CALIFORNIA COASTAL COMMISSION

W16c

CDP 5-18-0554 (CALIFORNIA DEPT. OF FISH &
WILDLIFE)
AUGUST 12, 2020

EXHIBITS

Encl: Annotated plan

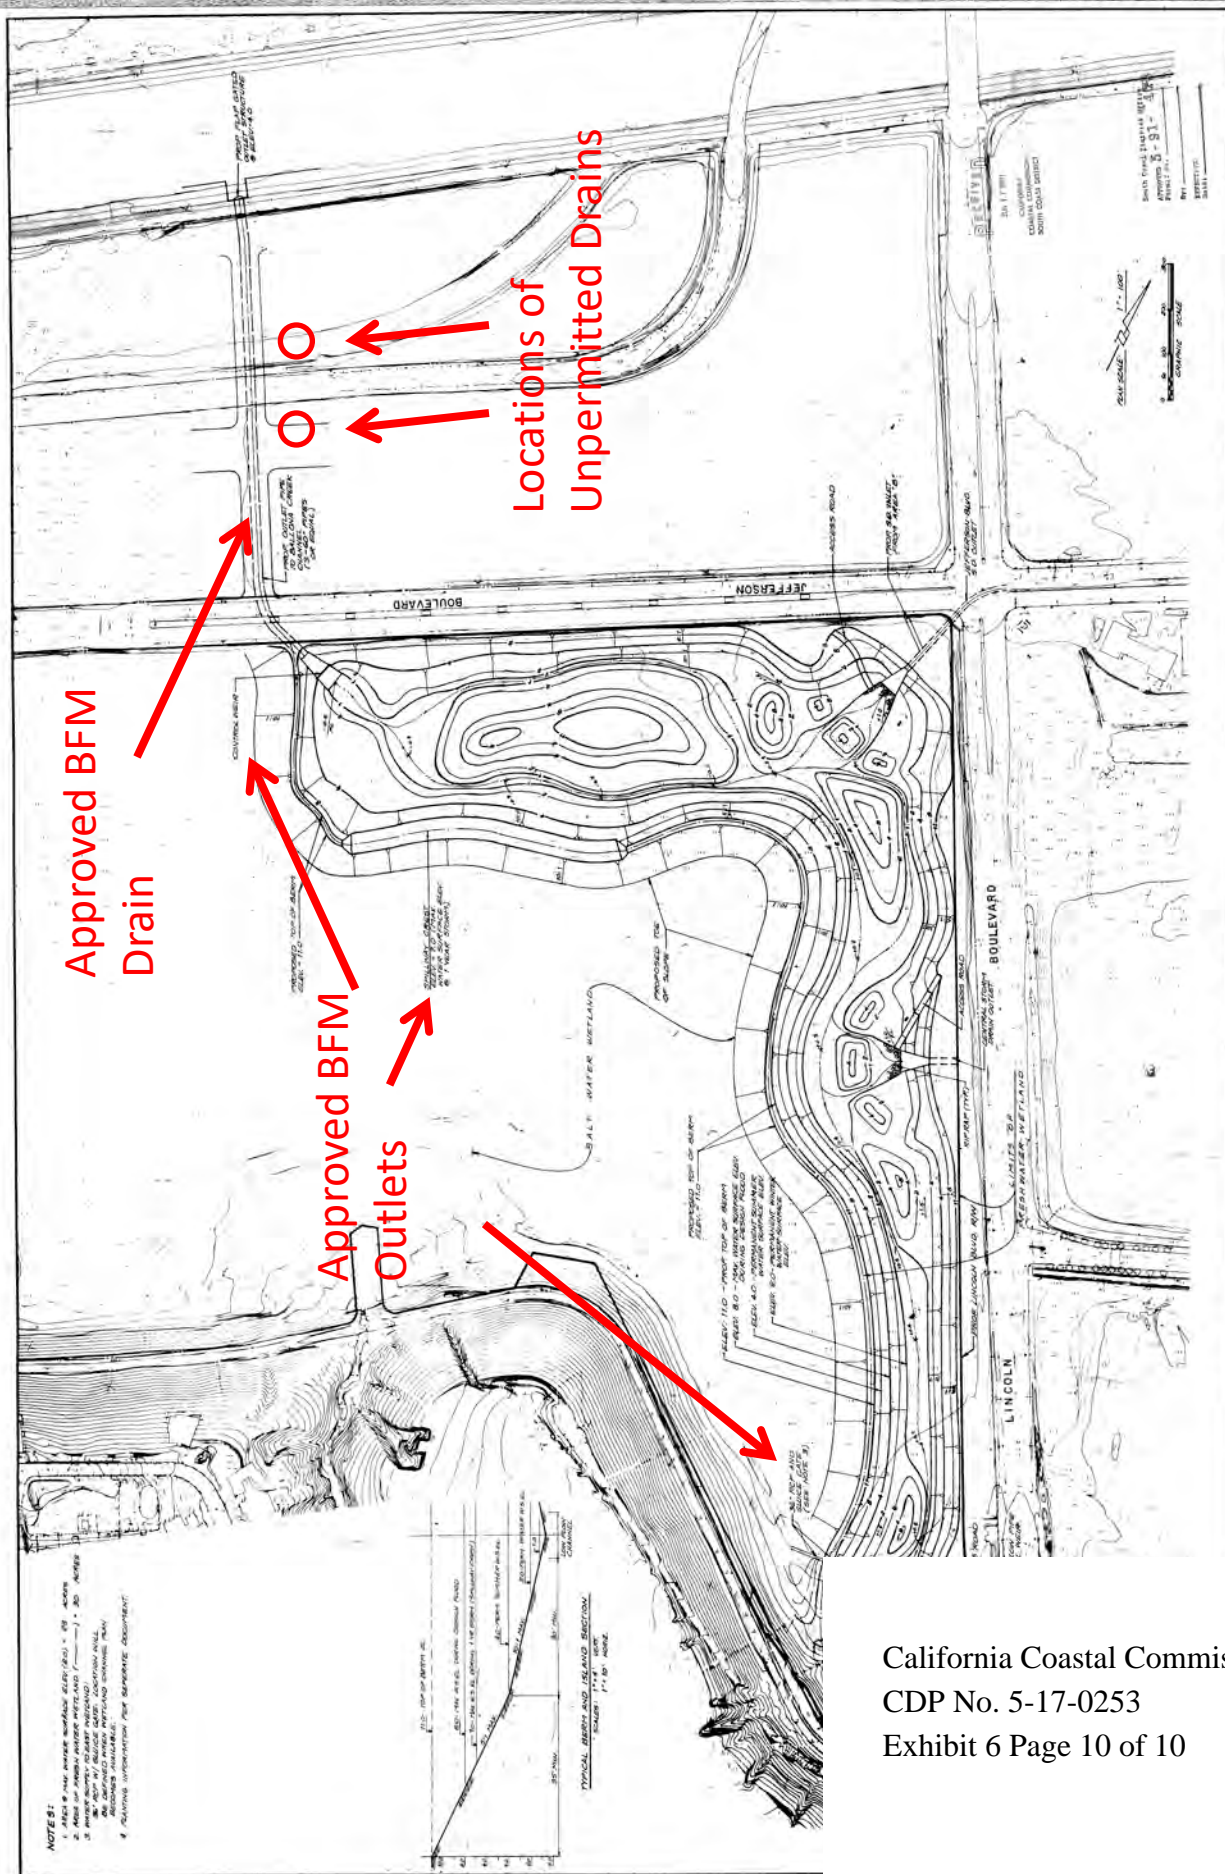
The two unpermitted drains at issue ("Unpermitted Drains") are located in the Ballona Ecological Reserve, one north of Culver Boulevard and the other south of Culver Boulevard. The Unpermitted Drains are not located within the BFM, but instead within natural saltmarsh and habitat areas separated from the marsh area of the BFM by Jefferson Boulevard. The Unpermitted Drains are not described in the CDP application, nor are the drains identified in the plans submitted with the application and presented to the Commission for approval. Thus the Unpermitted Drains were never authorized through the CDP, or by the Commission in any way that we are aware of.

As a point of clarification since your letter appears to conflate several separate structures, the Commission-approved BFM main drain line and the two other outlets from the BFM (in addition to the main drain line) that are critical to maintaining water levels in the BFM, and which are specifically identified in the CDP application and accompanying plans ("Approved BFM Drain" and "Approved BFM Outlets"), are not at issue in this enforcement matter. Each of these components is identified and described in the CDP application and accompanying plans, which comprise the development approved by the Commission via the CDP. By contrast, the Unpermitted Drains were not identified in the CDP application or its accompanying materials or plans. For reference I've attached a site plan submitted to the Coastal Commission that show the Approved BFM Drain and the Approved BFM Outlets. I've also annotated the plan to show the locations of the Unpermitted Drains, which are not depicted on the approved plan.

Clearly none of these descriptions pertain to the Unpermitted Drains. The Unpermitted Drains can be further distinguished from the Approved BFM Outlets in a number of ways. First, the Unpermitted Drains are not depicted in the CDP application or the plans, as the Approved Outlets are, and thus the Unpermitted Drains were not approved by the Commission. Second, the Unpermitted Drains are not outlet drains. The Approved BFM Outlets provide outlets for freshwater water to move from the BFM into Ballona Channel and into the saltmarsh west of the BFM for salinity level management purposes. In contrast, the Unpermitted Drains do not outlet water from the BFM. Thus, categorically, the Unpermitted Drains are not "outlets" from the BFM. Instead, they drain water from native habitat and a wetland area separated from the BFM by Jefferson Boulevard. Third, the Unpermitted Drains do not direct drained water into the saltmarsh, thus they also do not share the function of the Approved BFM Outlets to provide the saltmarsh with freshwater. Finally, the saltmarsh that is protected by the Approved BFM Outlets that is referenced in the CDP application and associated documents is west of the BFM. In contrast, the Unpermitted Drains are located in the saltmarsh and habitat area north of the BFM.

Exhibit B. North Drain Vegetation

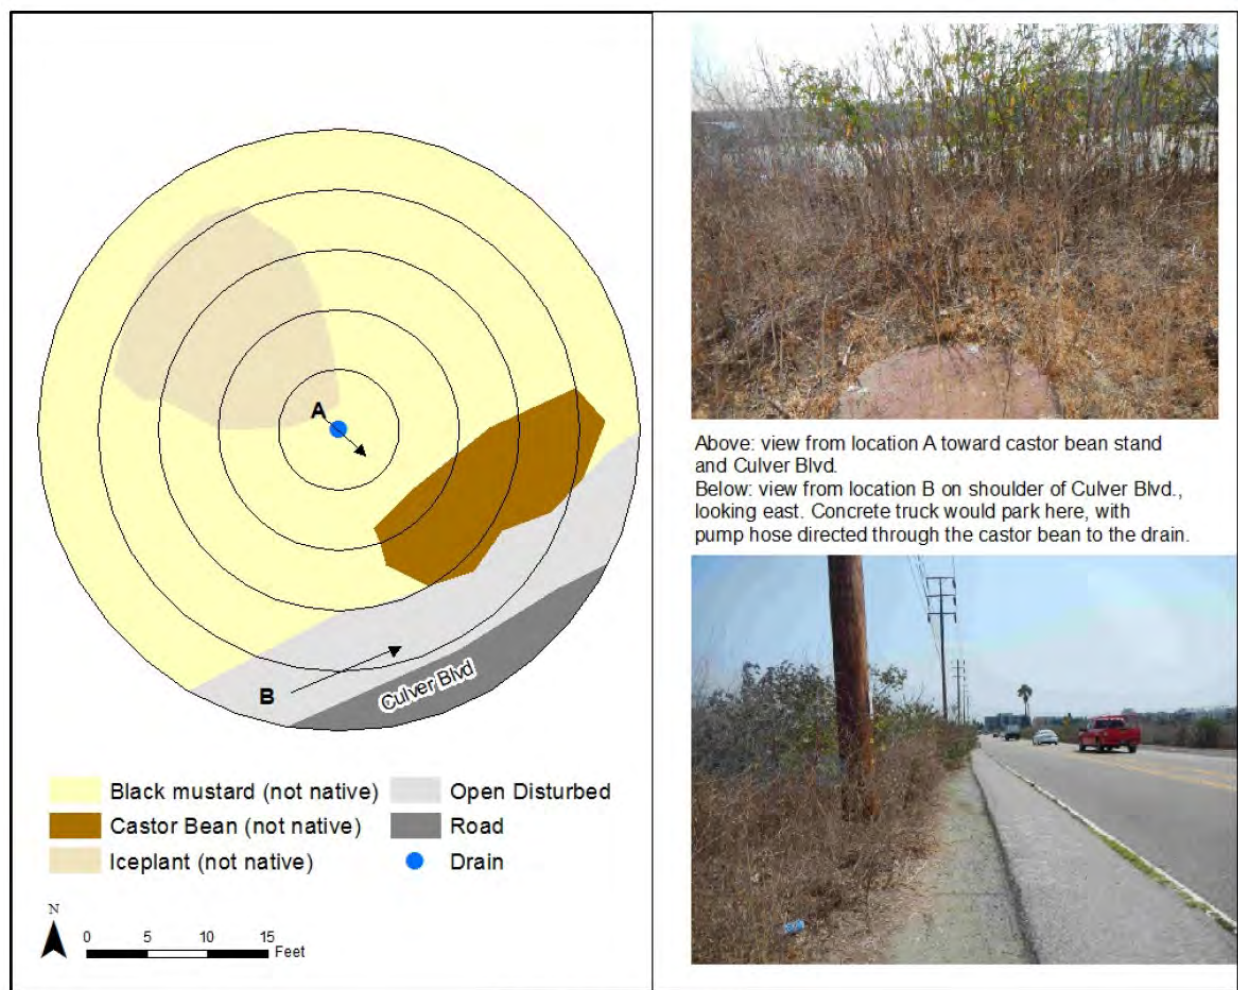
*This area is occupied entirely by non-native weedy vegetation, primarily iceplant (*Carpobrotus edulis*), black mustard (*Brassica nigra*), and castor bean (*Ricinus communis*). This drain is about 15 feet north of Culver Boulevard below a stand of castor bean. (Figure 3)*

around the north drain was the same as the overall surrounding area; disturbed upland ruderal habitat. I observed that the north drain riser was not topographically situated to remove water from the area because it was not located in much of a perceptible depression. The area surrounding the south drain was in a slight depression that was enabling water to pond and I could envision water draining out of the area during and after big storms (Figure 5). My thought is that, along with residual salt in the soil, ponding storm water would facilitate and account for the occurrence of small patches of saltmarsh plants.

Exhibit C. South Drain Vegetation

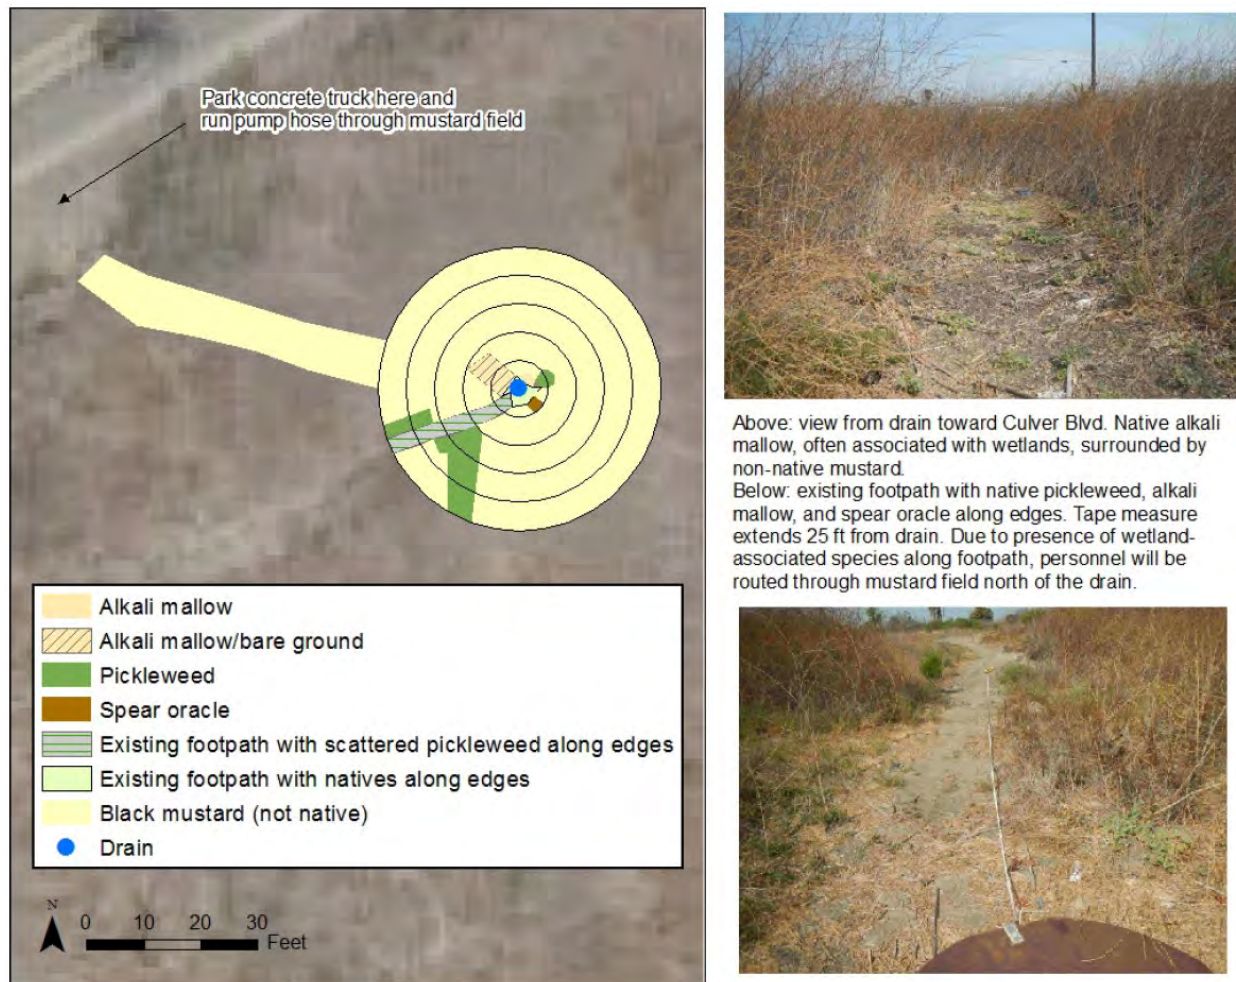
*Unlike the north drain, this drain has patches of wetland-associated species growing in disturbed areas where black mustard is less prevalent. These species include pickleweed (*Salicornia pacifica*), spear oracle (*Atriplex patula*), and alkali mallow (*Malvella leprosa*). (Figure 4)*

From PSOMAS hydrology report, 400 sq. ft. of wetland (saltmarsh) immediately around the South Culver debris drain riser was subject to impacts (subject to water removal).

Figure 2: South Drain Reading Directly in Front of Air Leak (water poured over to expose leak)

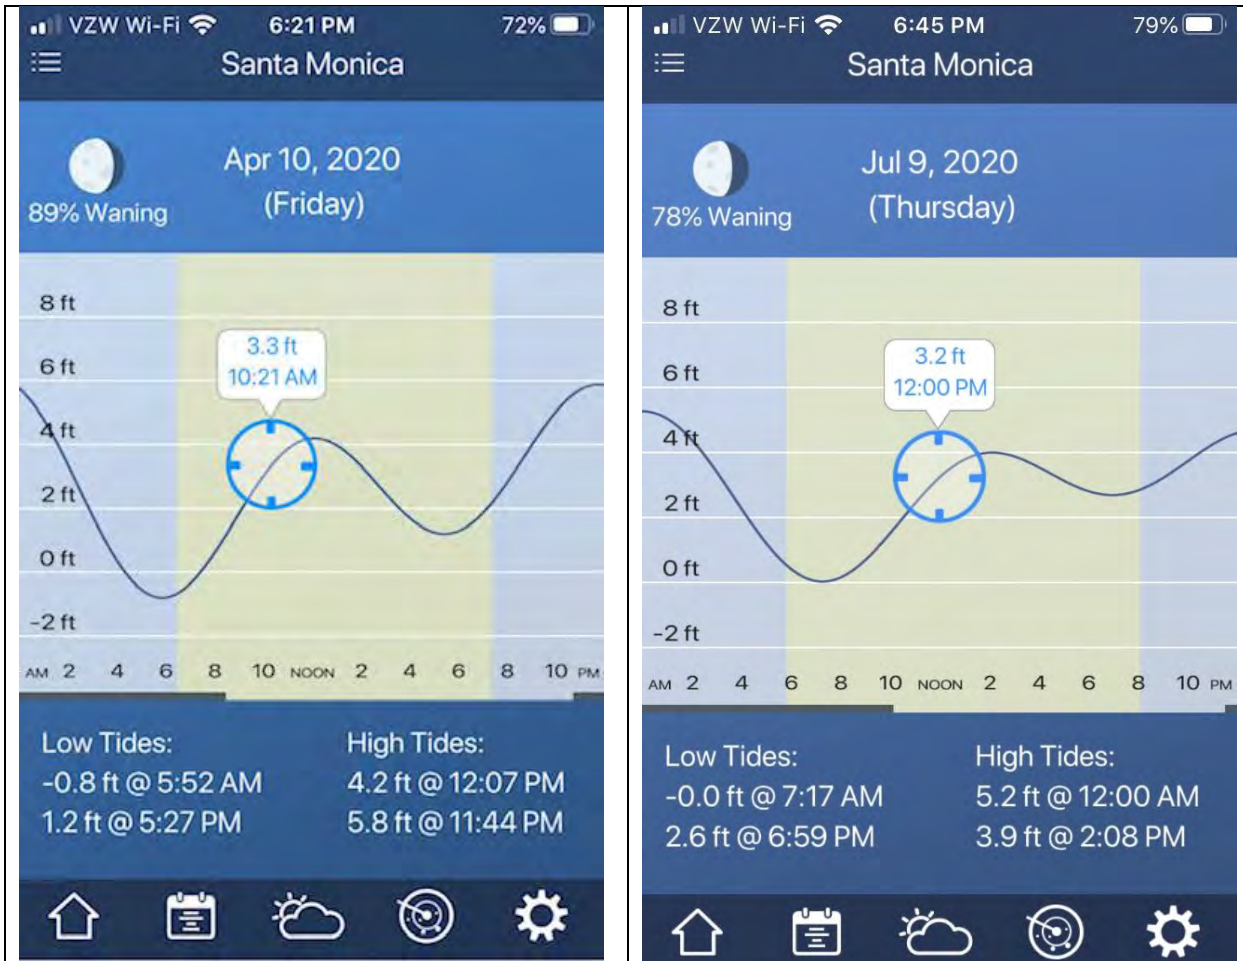
In response to Ms. McPherson's claim that methane is escaping from the leak in the seal, the Department requested that the Los Angeles county Fire Department Health Hazmat personnel measure for any harmful gas leaks. On July 09, 2020 from approximately 1145-1215 hrs., Department staff met Los Angeles County Fire Department Health Hazmat personnel (HazMat) at the north and south drains attempting to detect and/or measure any potential hazardous gas present and/or escaping from the risers.
